Our Ref: AK/ak24026/23-020

Date 2nd February 2024

Re: Sumners Pond Fishery and Campsite, Chapel Road, Barns Green, West Sussex, RH13 0PR

We are writing in relation to your letter dated 12th December 2023.

COMPARISON OF FEH22 VS FEH13 RAINFALL DEPTHS

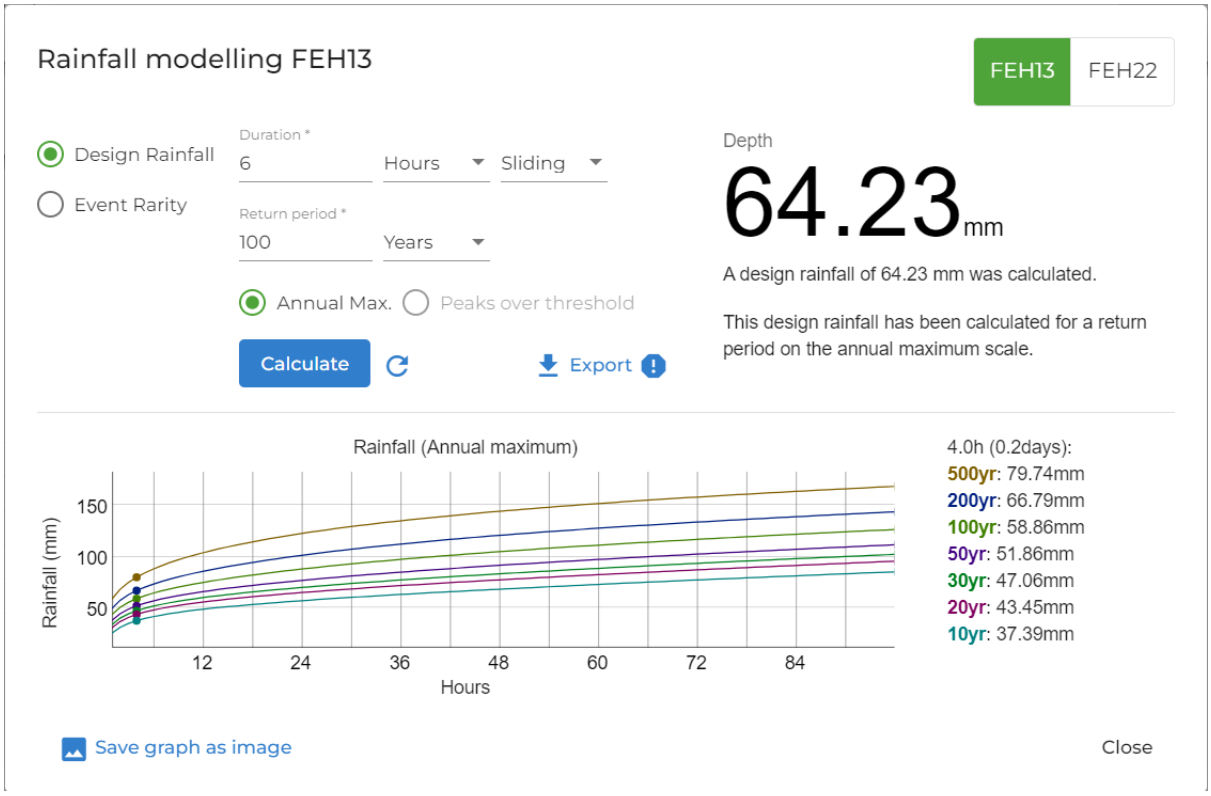
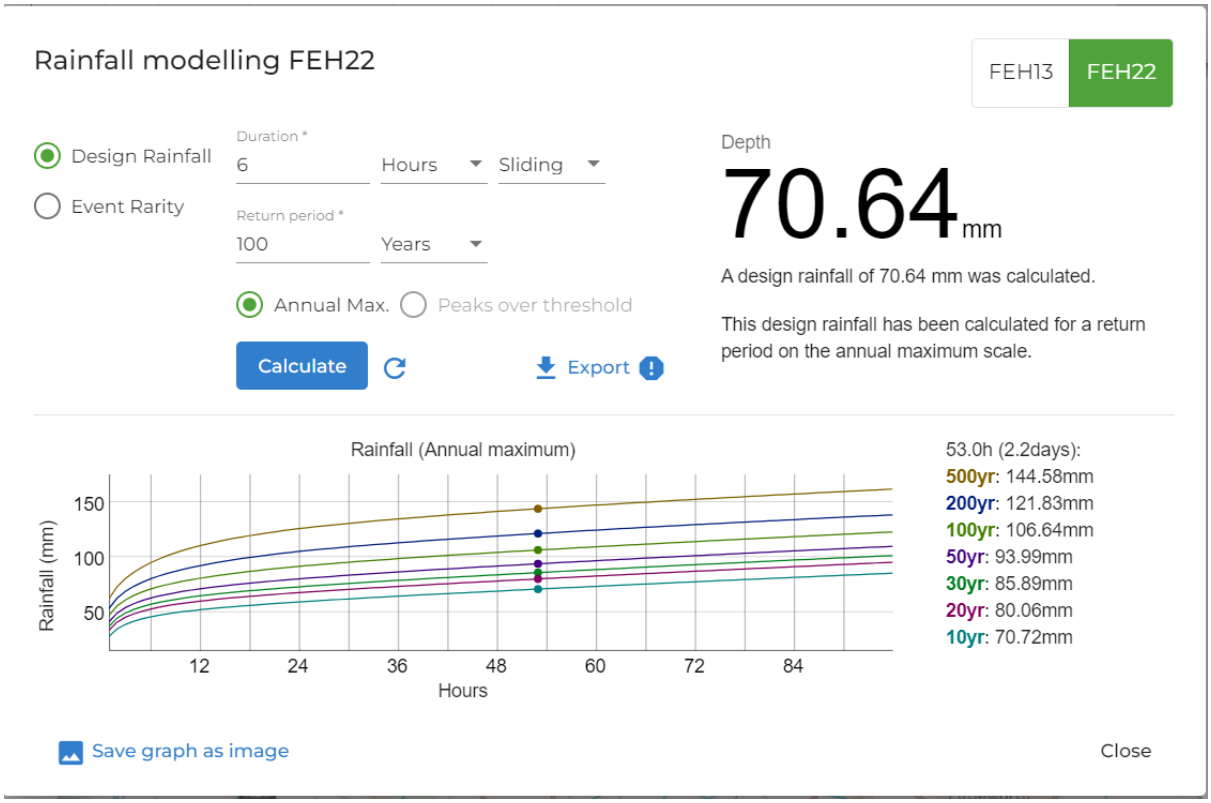
3. *FEH2022 network drainage calculations for the proposed development surface water should be provided for the following return periods…* Microdrainage software that was used to model the SW networks do not directly support FEH22 rainfall data. However, we have compared the FEH22 and FEH13 rainfall depths – as per attached comparison sheet – and as a result we have increased the modelled input flows by 10% (which was the approximate increase in rainfall depth when comparing FEH13 and FEH22 data for the 6 hour storm with the return period of 1 in 100 years).

FEH22 / FEH13 = 27.21 / 25.31 = 1.075;

FEH22 rainfall approximately 8% greater than equivalent FEH13

FEH22 / FEH13 = 70.64 / 64.23 = 1.099;
